EMAIL AND ATTACHED SITE 3 DRAFT FINAL PROPOSED PLAN AND SCHEDULE NWS YORKTOWN VA
04/18/2014
CH2M HILL

Draft Final Proposed Plan

Site 3
Naval Weapons Station Yorktown
Yorktown, Virginia
February 2014

Figure 3. Groundwater Contamination

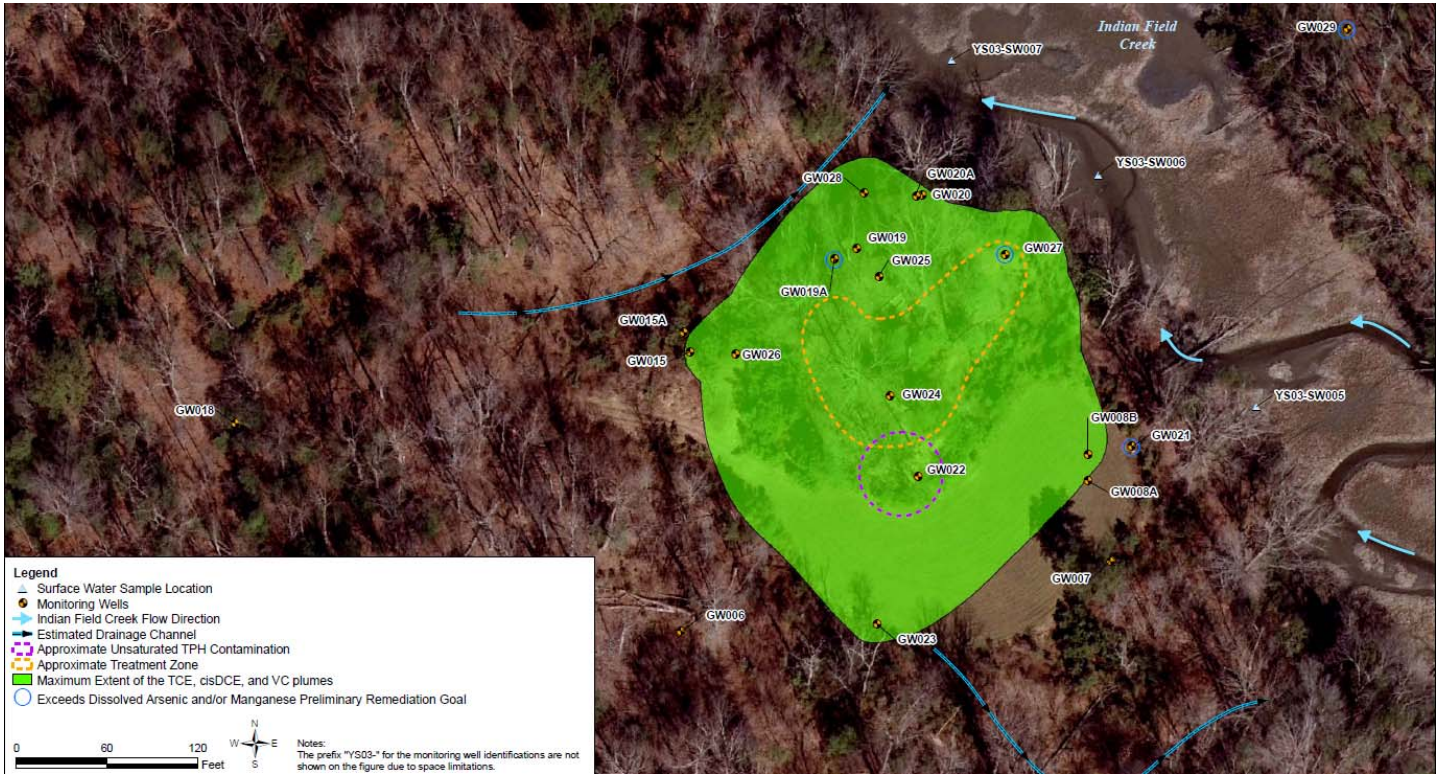
Commented [WS27]: Should state cis-1,2-DCE in Legend

Commented [WS28]: Recommend making exceedances different color than flow and drainage

Navy response: Will revise "cis-DCE" in the legend to "cis-1,2-DCE"

Navy response: Revisions will be made before finalizing the document.
